**STAFF REPORT:** 4/14/2021 MEETING

**APPLICATION NUMBER:** 21-7172

**ADDRESS:** 791 SEMINOLE

**SCOPE:** REHABILITATE HOME; REPLACE WINDOWS & REPIAR AND REPLCE SIDING AND TRIM

DRAWING TITLE		
EXTERIOR ELEVATIONS		
SCALE		
1/4" = 1'-0"		
DRAWN BY		
K.A.K.		
CHECKED BY		
ISSUE DATE:		
4-8-21		
REVISED	DATE	COMMENTS
PHASE		
SCHEMATIC		
SHEET No.		
A.300

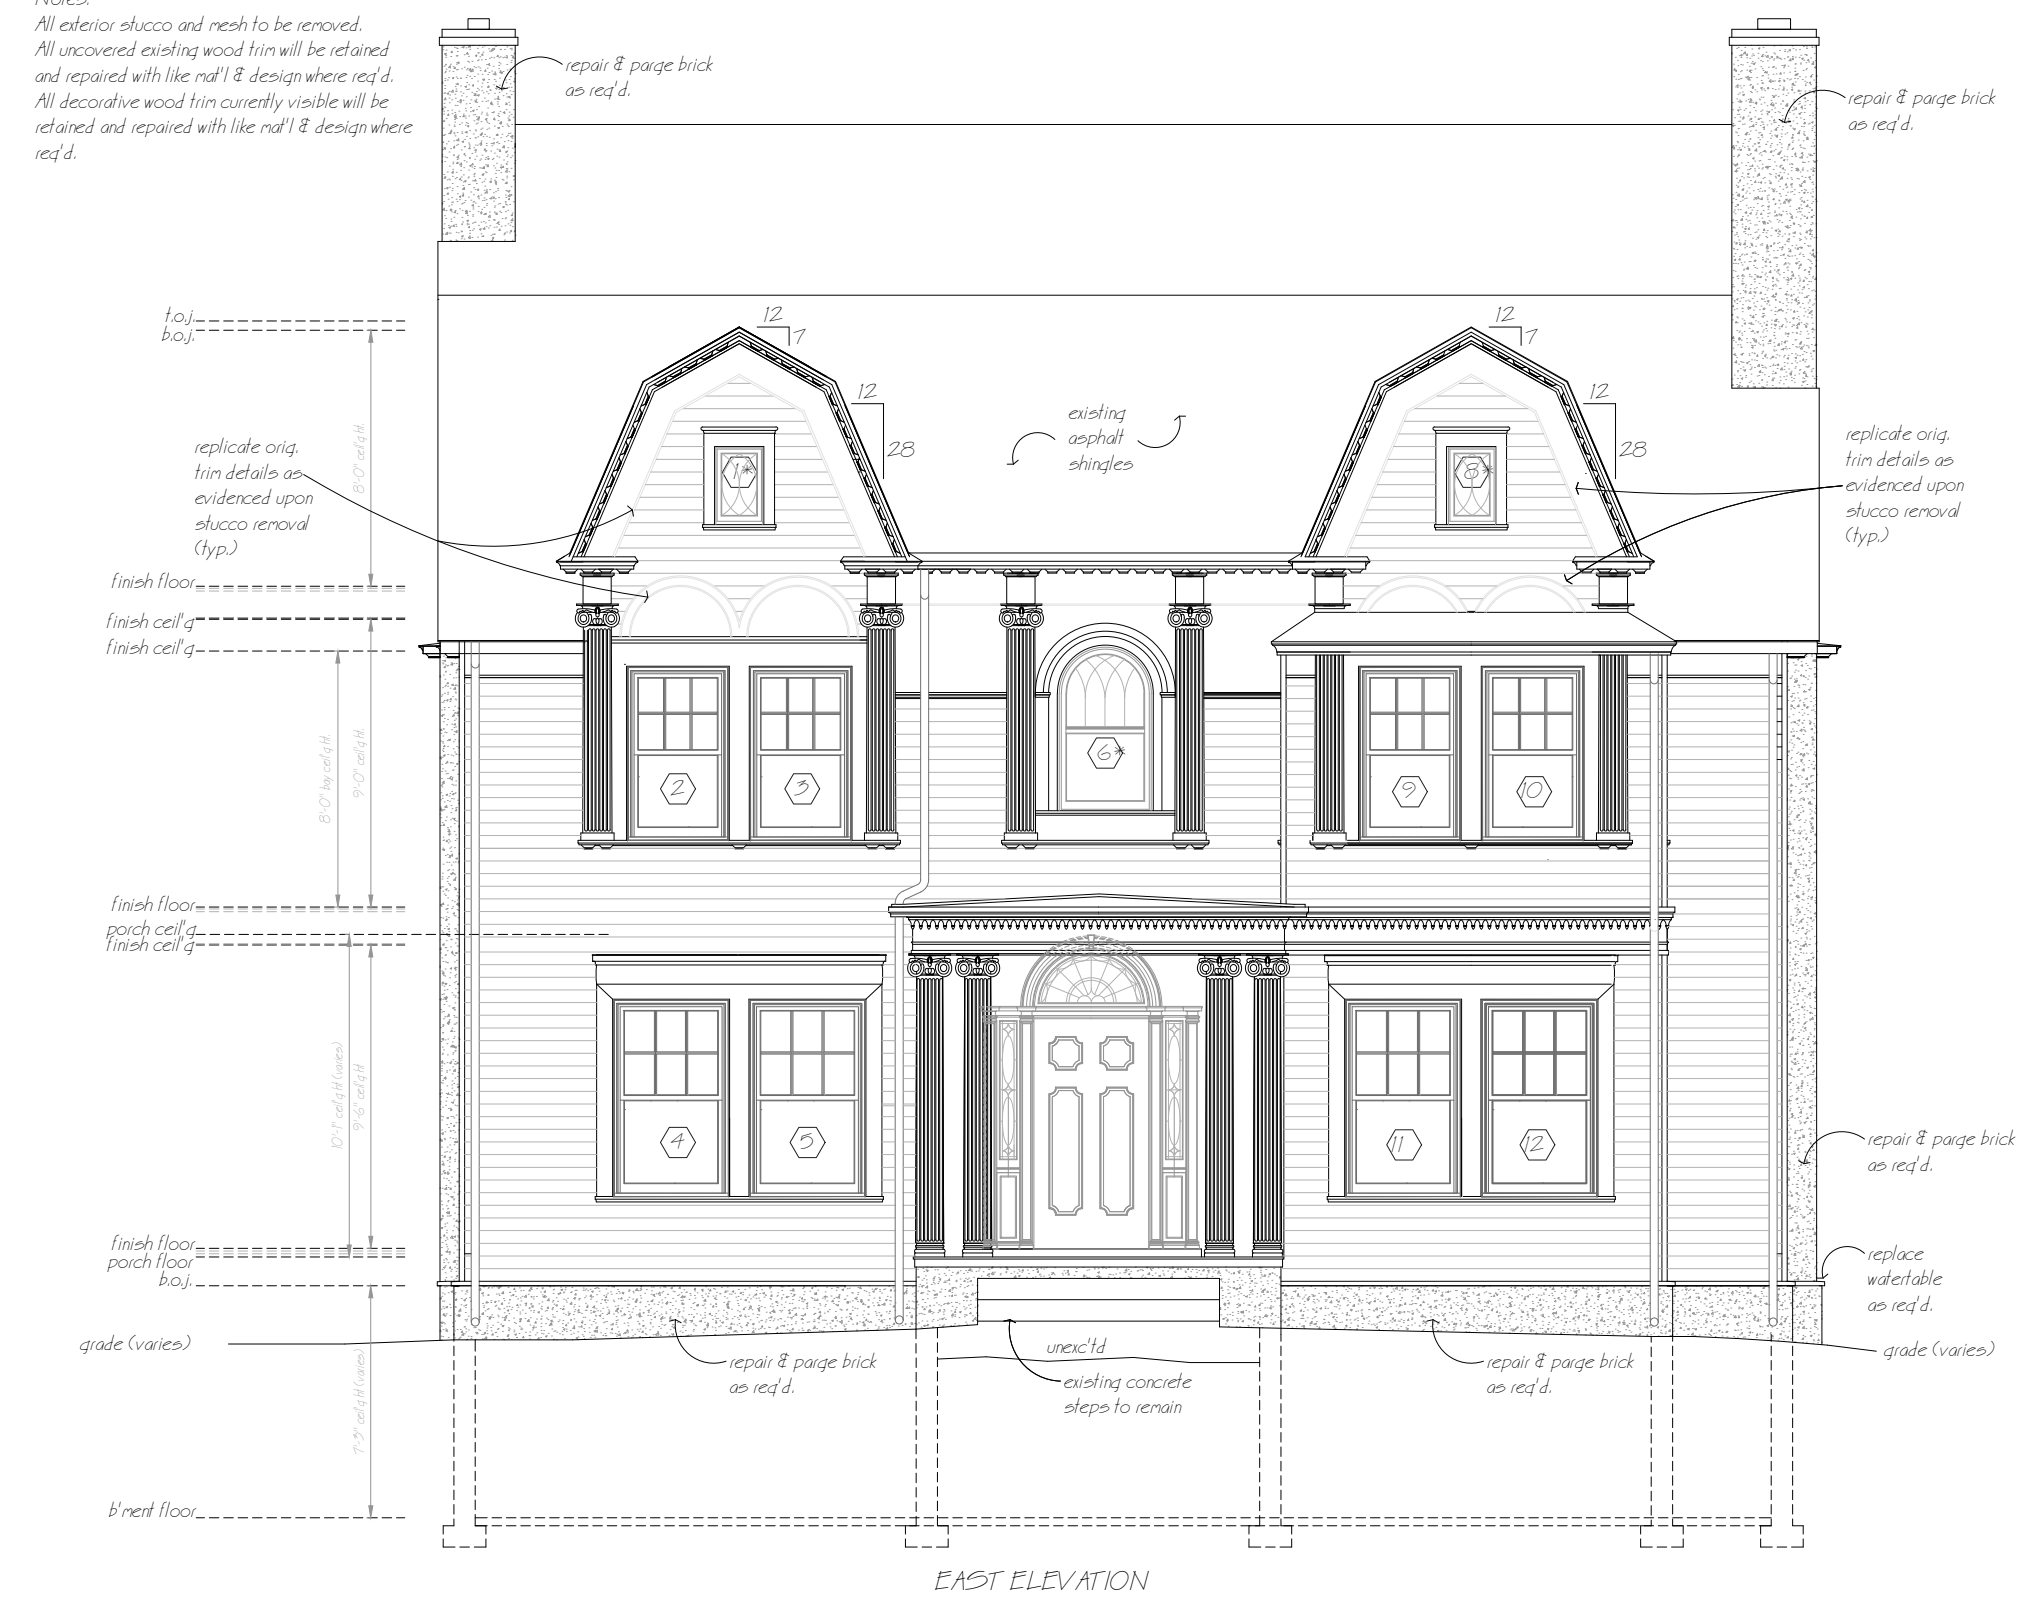
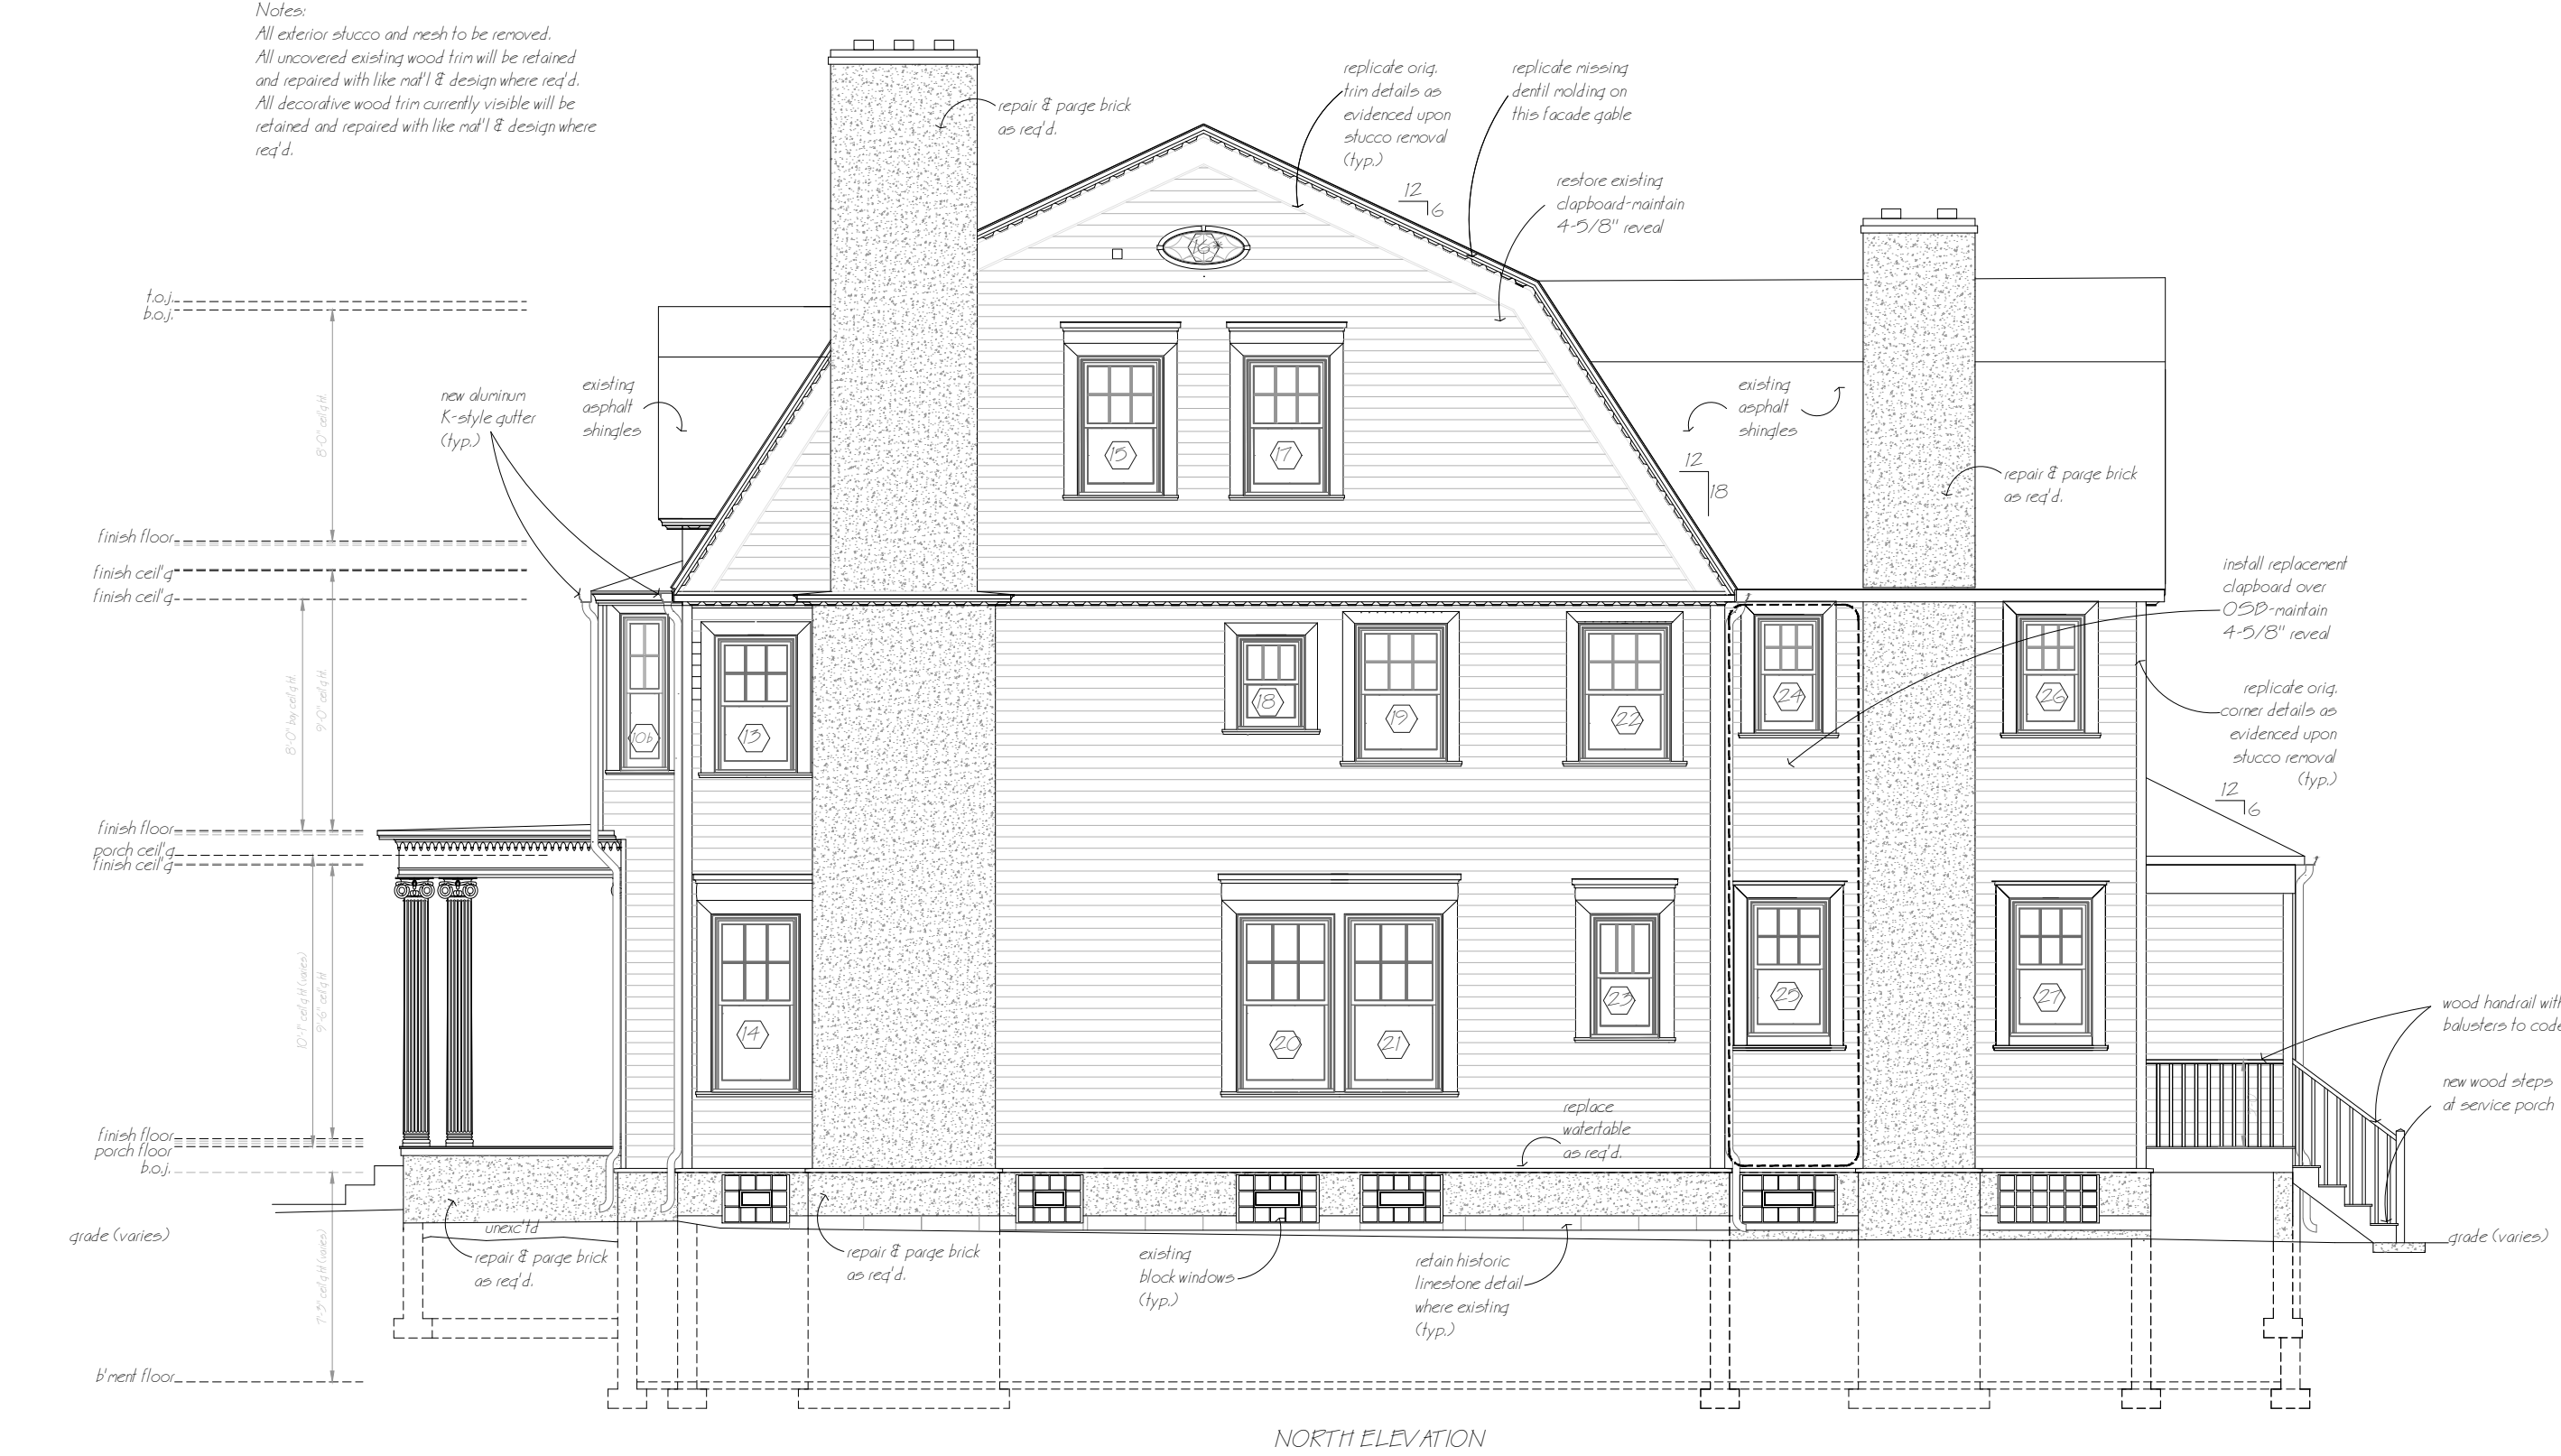
- The project's final construction drawings shall be revised to clearly delineate all extant exterior elements which shall be retained and repaired and the final design of the two rear porches. The revised/final drawings shall be submitted to HDC staff for review and approval prior to the issuance of the project permit
- All proposed new fencing shall be stained or painted a color which complements the home on or before April 14, 2022. The applicant shall provide a final painting proposal to HDC for review and approval prior to the issuance of the project's permit.
